PROPOSED PLAN 1:100

PROPOSED DOMESTIC GARAGE
AT
LAND OPPOSITE 82 GIANTS GRAVE ROAD

BRITON FERRY FOR MR KERRY STILLMAN

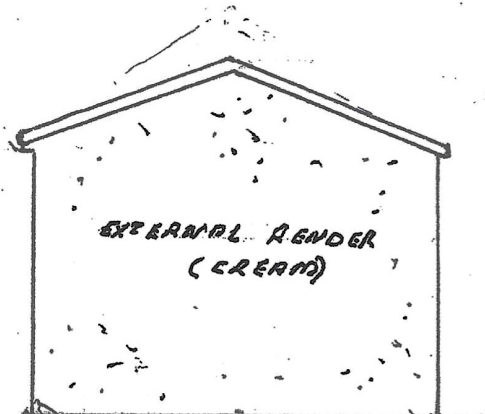
HIGHWAYS

RECOMMENDED:-

- 1) MINIMUM 5.5M
NOW SHOWN
- 2) REDUCE HEIGHT FRONT
WALL TO 1 METRE - NOW
SHOWN
- 3) ROLLER SHUTTER DOORS
(ALREADY SHOWN)
- 4) GATE, NOW SHOWN
SEE THROUGH AND ONLY
OPENING IN
- 5) AREA LEADING TO GARAGE
HARD SURFACE FOR 2 METRES
MAX GRADIENT 1 IN 9
DRAINED AS SHOWN

WALL REDUCED
TO 1 METRE
HEIGHT

AREA DRAINED TO
SOPWASH: NO
RAINWATER TO
LEAVE THE SITE

NEW ENTRANCE
GATES, L.H.

OPENING 1.80M
SEE THROUGH AND
OPENING IN WALLS
ONLY
